HULL MARINE TOWBO CORP HULL #30

TIDEWATER MARINE SERVICE

143'x36'x16' SEISMIC VESSEL

MAIN DECK AND BOTTOM SCANTLING

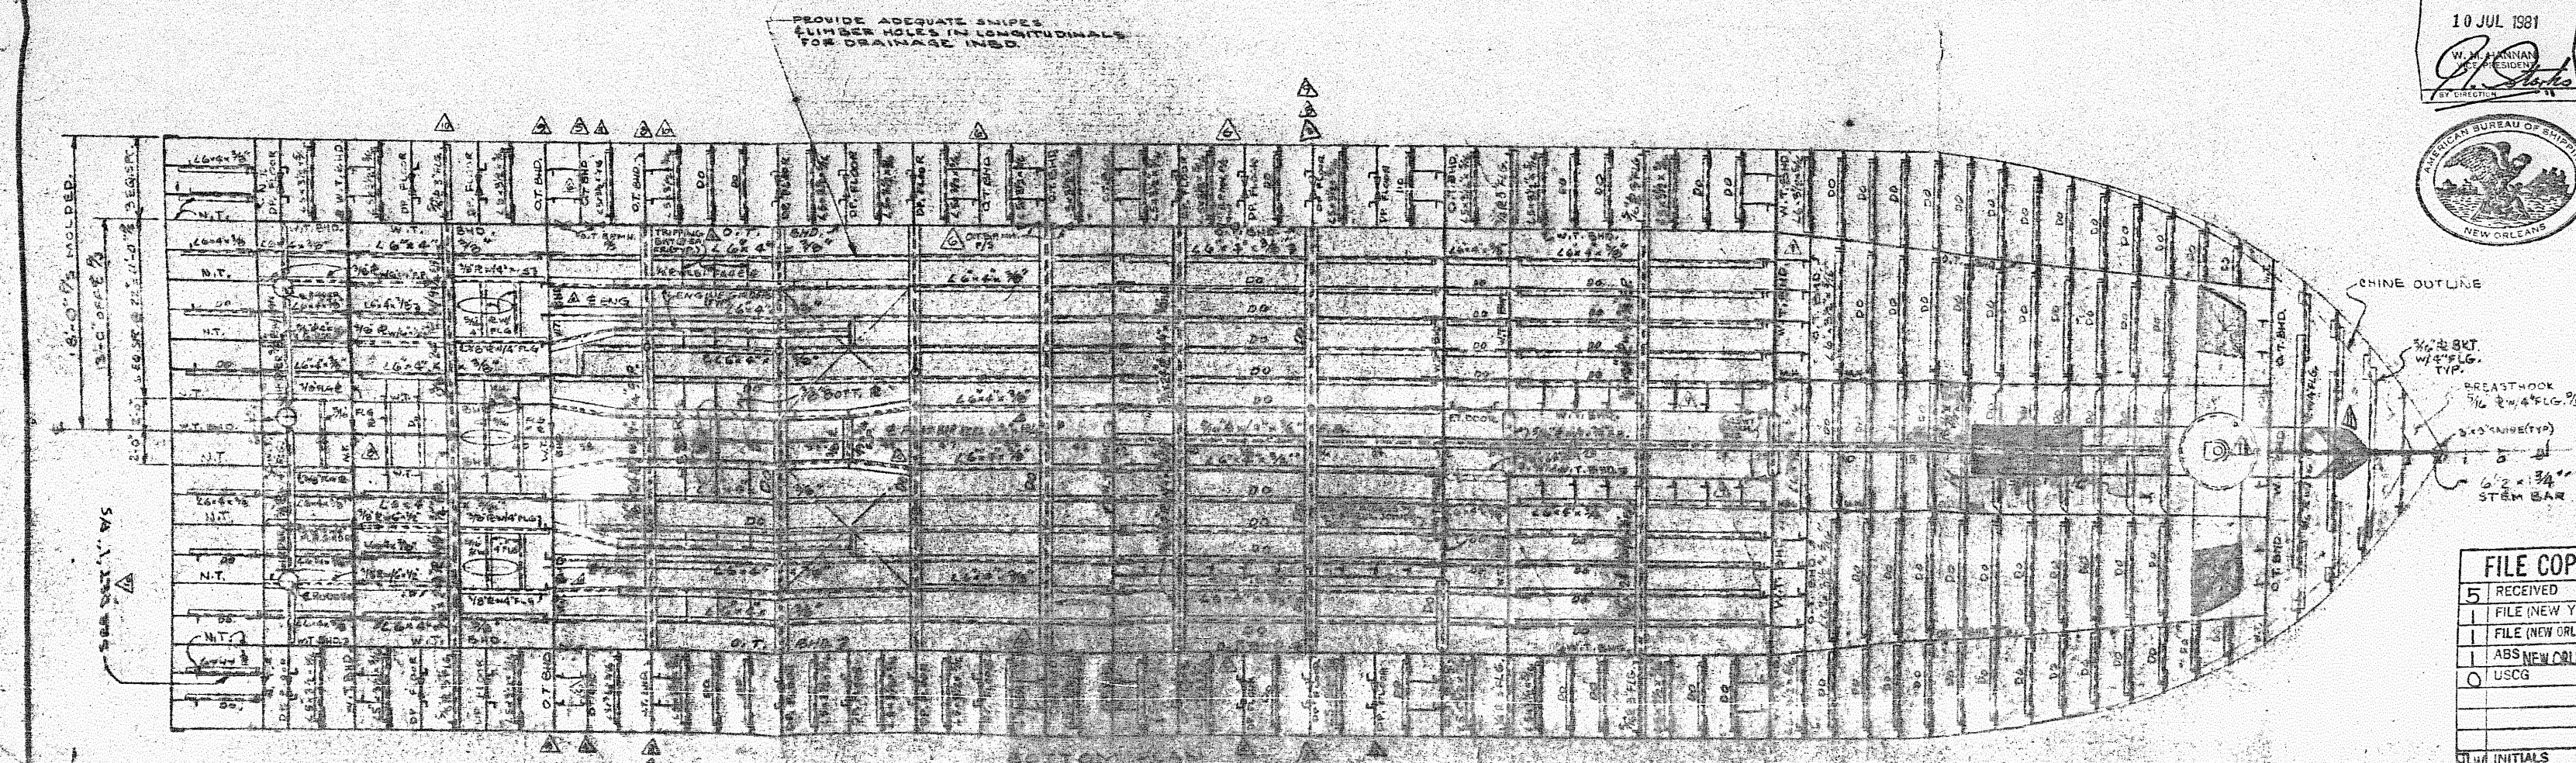
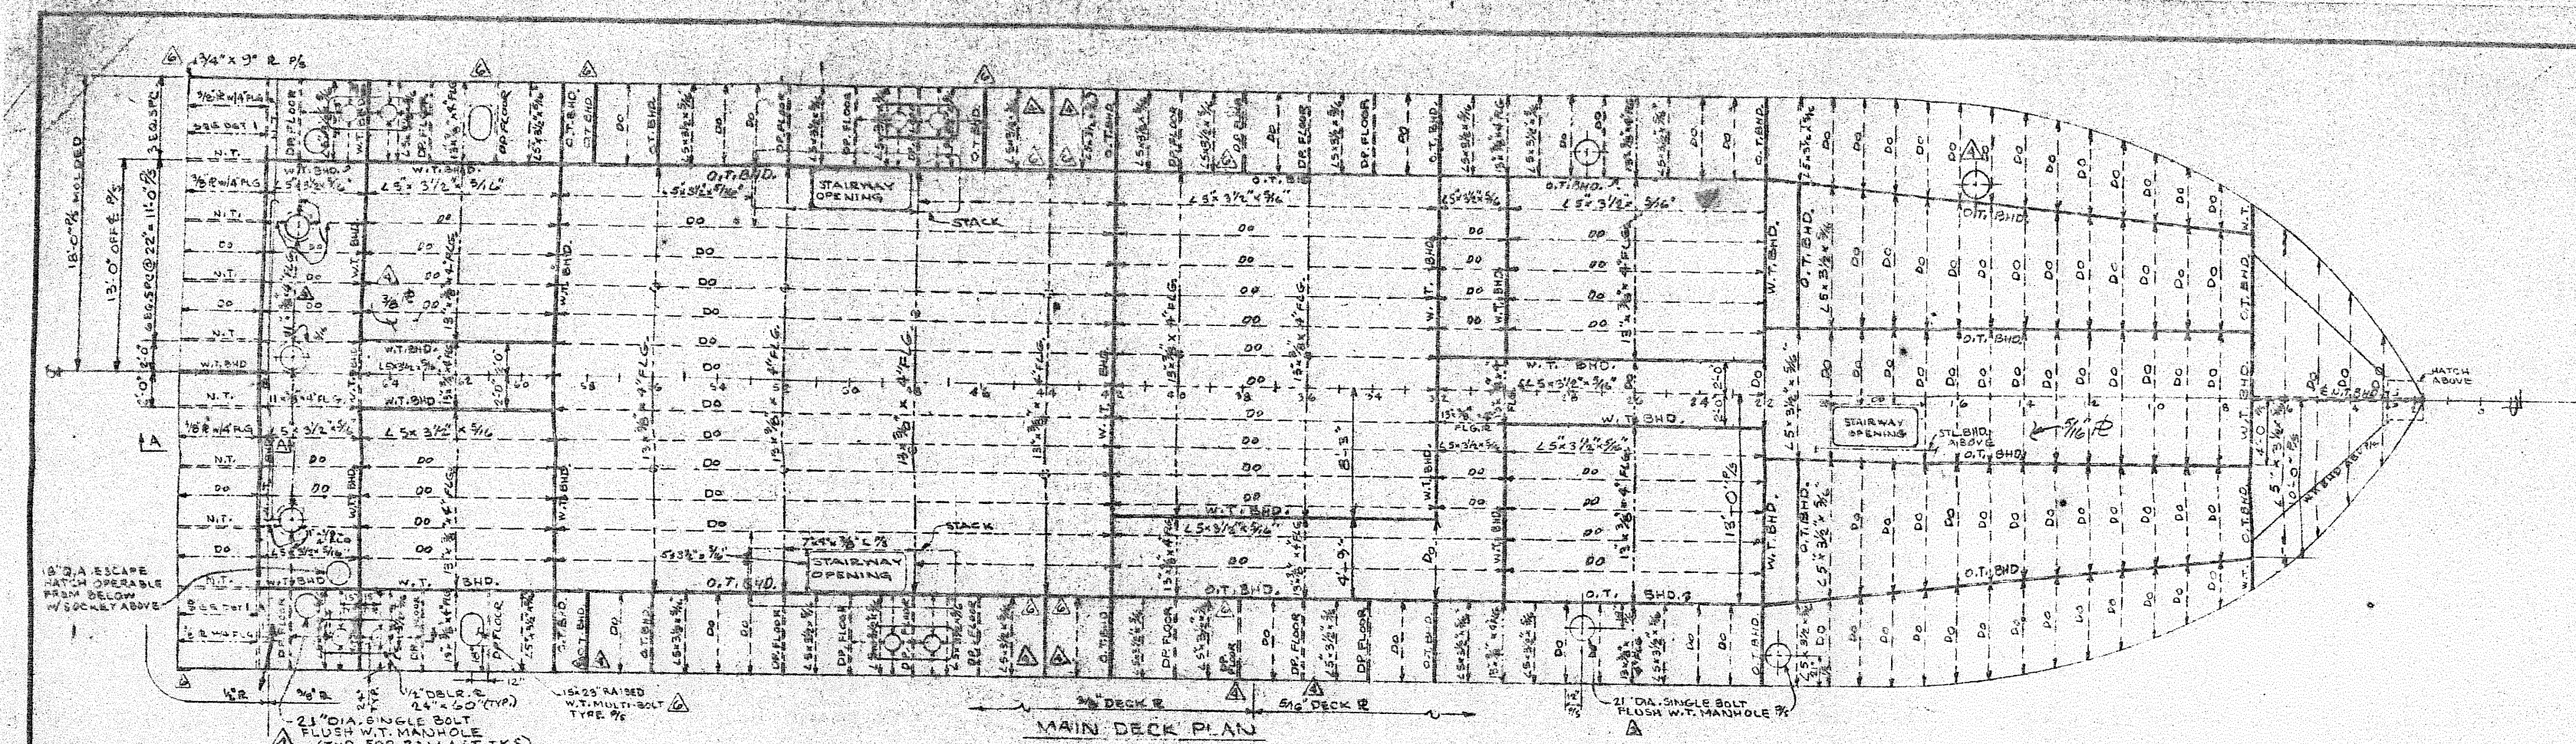
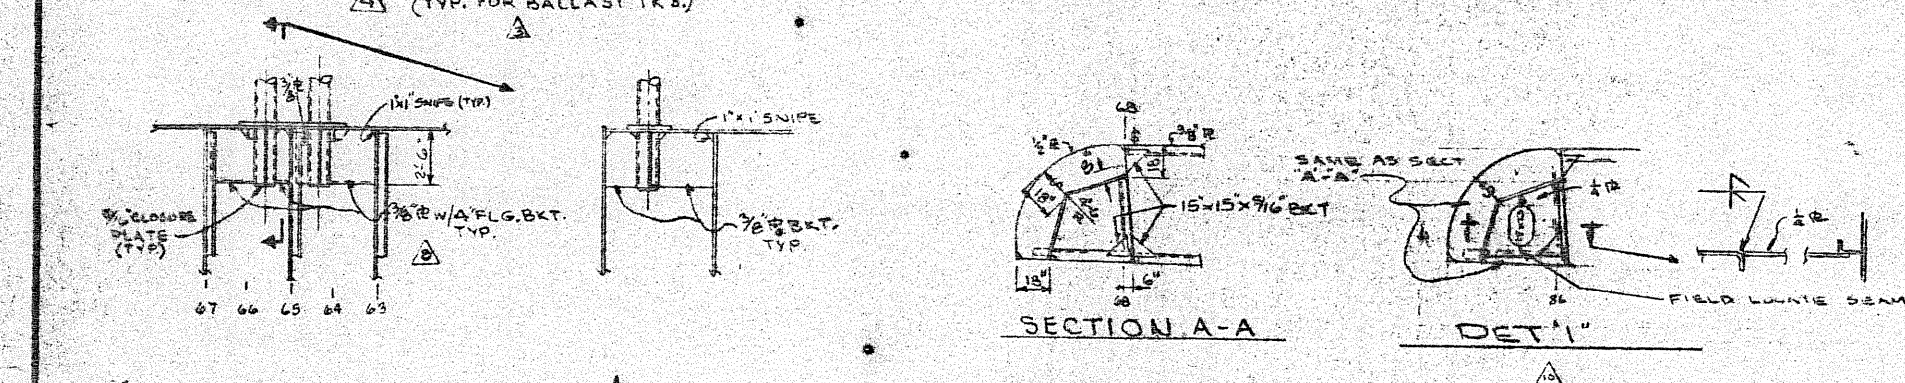
SUBMIT DETAILS:

- RUDDER & STRUTS
- PILOT HOUSE FRONT
- VENTS
- AFT FASCLE BMD
- BULWARK

VENT HEIGHTS:

- TANKS FWD FR 32, 18' ABOVE FASCLE
- EXCEPT FUEL OIL TANK (30' ABOVE MAIN DECK)
- TANKS AFT FR 32, 30' ABOVE MAIN DECK
- MAX SP. GR. OF LIQUID CARGO = 1.05
